RICHARD L. MEEHAN

Re: Dairi Prima Minerals (DPM) Mine site risks and Tailings disposal safety. Review of Dairi April 2021 EIA Addendum.

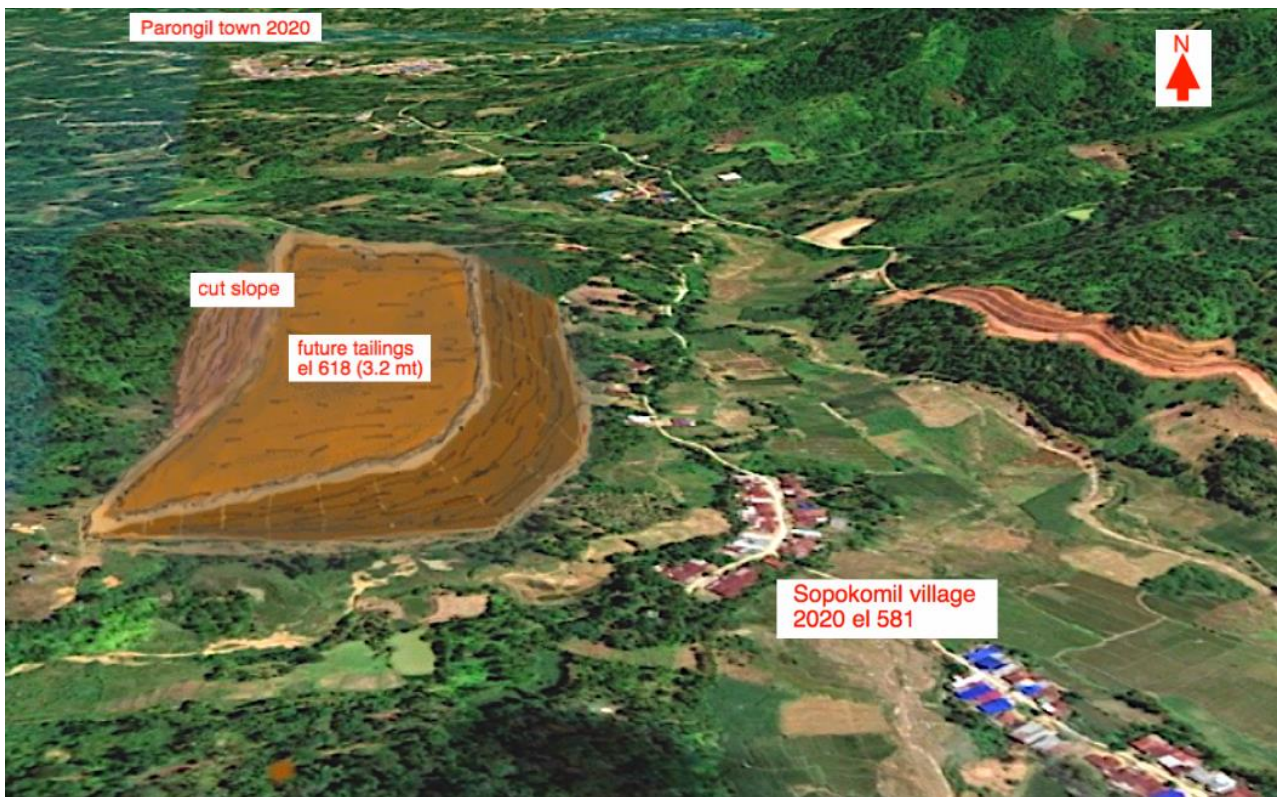
Figure 1. Planned configuration of TSF, 3.2 million tons at elevation 618. TSF configuration (brown color) from EIA Addendum fig 2.22 sketched onto Google Earth image by the author. Breach of the tailings dam above the Sopokomil village is likely in a strong earthquake because the ground between and beneath the village and the TSF and the dam foundation is unstable volcanic ash soils subject to liquefaction and landsliding.

Figure 5 Cross section as verified EIA2021 with likely ground failure scenario brought on by rain and earthquake

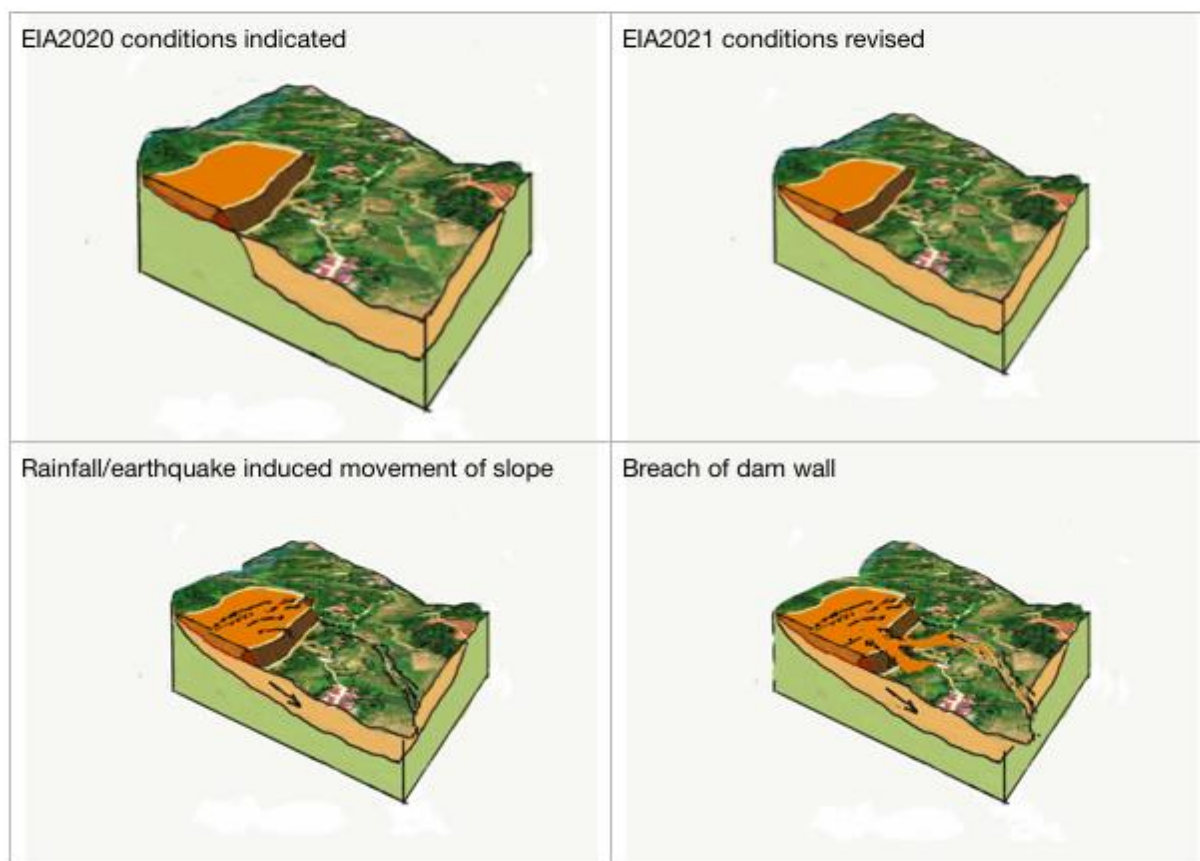
The scenario I have in mind is illustrated on the sequence of images on figure 3 and figure 4. Basically, the whole slope on which the TSF is located could move downslope under the weight of the TSF (indeed, Toba tuff has seen similar landslides (see Appendix A) even without loading associated with a TSF). The lower bound of sliding may be within in the Toba tuff layer or at zones of weakness and high pore pressure at the base of the tuff. With such a movement it is difficult to believe that the proposed TSF would not fail, either collapse or by rupture of linings.

Figure 13 EIA2021 shows landslide potential adjoining TSF

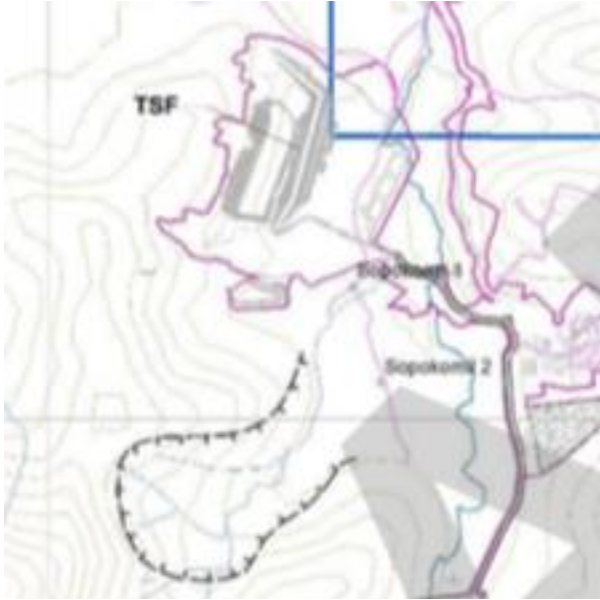
The landslides are attributed to the presence of the Toba tuff and although the EIA does not show landsliding at the TSF site itself there is reason to believe that the area is also unstable even without the presence of a TSF. The added weight of the TSF whether of short term or long term size, would aggravate the existing instability.
